29 August 2018

We were pleased to hear that, as part of Global Sea Mineral Resources' (GSR) efforts to explore the feasibility of deep sea mining of polymetallic nodules, GSR have decided to publish their environmental impact statement (submitted on 30 March 2018 to the International Seabed Authority) in the interests of stakeholder transparency. We also welcome the formal consultation period and opportunity to comment on the documentation. We have evaluated the document, which is generally well presented, informative and appropriate, and would like to provide some technical comments (provided below this letter).

## GSR Environmental Impact Statement Comments

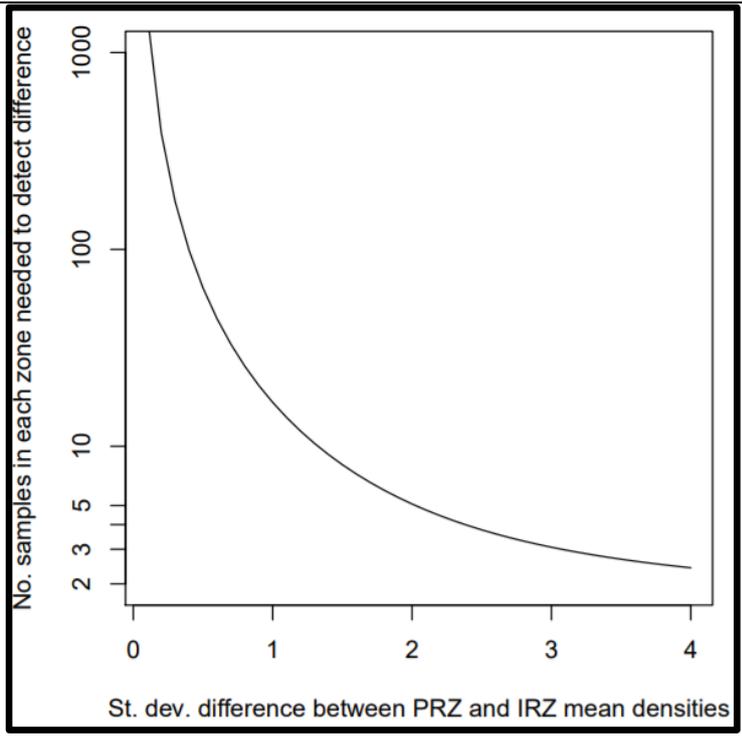
EMMP			It appears that five samples will be taken for each parameter in the control site (RA), impacted site (IRZ) and Plume impacted site (PIRZ). The numbers are tentative (p 169). Assuming that the data will be analysed by some sort of ANOVA design (the EIS doesn't say) then statistical theory allows us to predict the effect size (measured as number of standard deviations the mean of the impacted site is away from the mean of the control site). The graph below shows this relationship:

**For 5 samples it means that over 2 standard deviation differences in the parameter of interest are needed to detect an effect (at 95% confidence level, which is normal for these tests). This is an enormous difference. According to Cohen 1988 (Statistical Power Analysis for the Behavioral Sciences) differences of > 0.5 are large. We strongly recommend that the EMMP attempts similar calculations and commits to a sampling plan that can be theoretically tested prior to implementation to ensure that it is sufficient to detect the sort of effects of interest.**
